Access Compliance Report

Public Rights-of-Way

(Curb Ramps)

Intersection ID: 13960	Main Street: CENTRAL_AV	Cross Street: KILBORNE_DR	Location: SE
ADA ID: 2FD221FFCBB1	Ramp Type: Para	Initial Pass/Fail: Fail	Overall Compliance: No
		Severity Score: 12.5

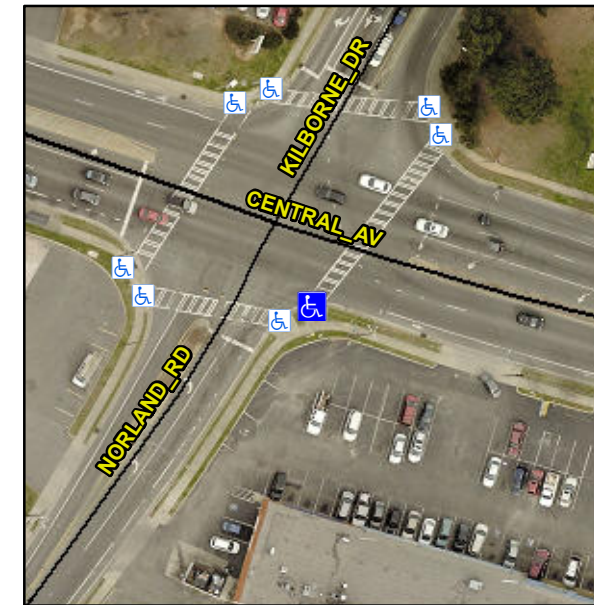
Surveyor Notes:

RT RP < 5%

PROW/ADA:

R304.3.2

Compliance	Description	Data	Compliance	Description	Data
N/A	Ramp Length LT (in)	36.5	N/A	Ramp Length RT (in)	43.0
Yes	Ramp Width LT (in)	60.5	Yes	Ramp Width RT (in)	60.5
No	Ramp Slope LT (%)	8.5	Yes	Ramp Slope RT (%)	4.0
Yes	Ramp XSlope LT (%)	0.5	Yes	Ramp XSlope RT (%)	1.8
N/A	Landing Length (in)	N/A	N/A	DWS Provided?	N/A
N/A	Landing Width (in)	N/A	N/A	DWS Contrast?	N/A
N/A	Landing Slope (%)	N/A	N/A	DWS Length (in)	N/A
N/A	Landing X Slope (%)	N/A	N/A	DWS Full Width?	N/A
N/A	Landing Curb? (Y/N)	N/A	N/A	DWS Offset (in)	N/A
N/A	Shared Landing?	N/A			
N/A	Gutter Ponding?	N/A	N/A	Gutter Slope (%)	N/A
N/A	Gutter Lip Ht (in)	N/A	N/A	Gutter X Slope (%)	N/A
N/A	Painted X Walk1?	Yes	N/A	Painted X Walk2?	N/A
	X Walk 1 Direction	To NE		X Walk 2 Direction	N/A
N/A	X Walk 1 Width (in)	83.0	N/A	X Walk 2 Width (in)	N/A
	X Walk 1 Slope (%)	2.5		X Walk 2 Slope (%)	N/A
	X Walk 1 X Slope (%)	2.2		X Walk 2 X Slope (%)	N/A
N/A	Ramp inside XWalk1?	Yes	N/A	Ramp inside XWalk2?	N/A

Possible Solutions:

Remove & Replace Entire Ramp.
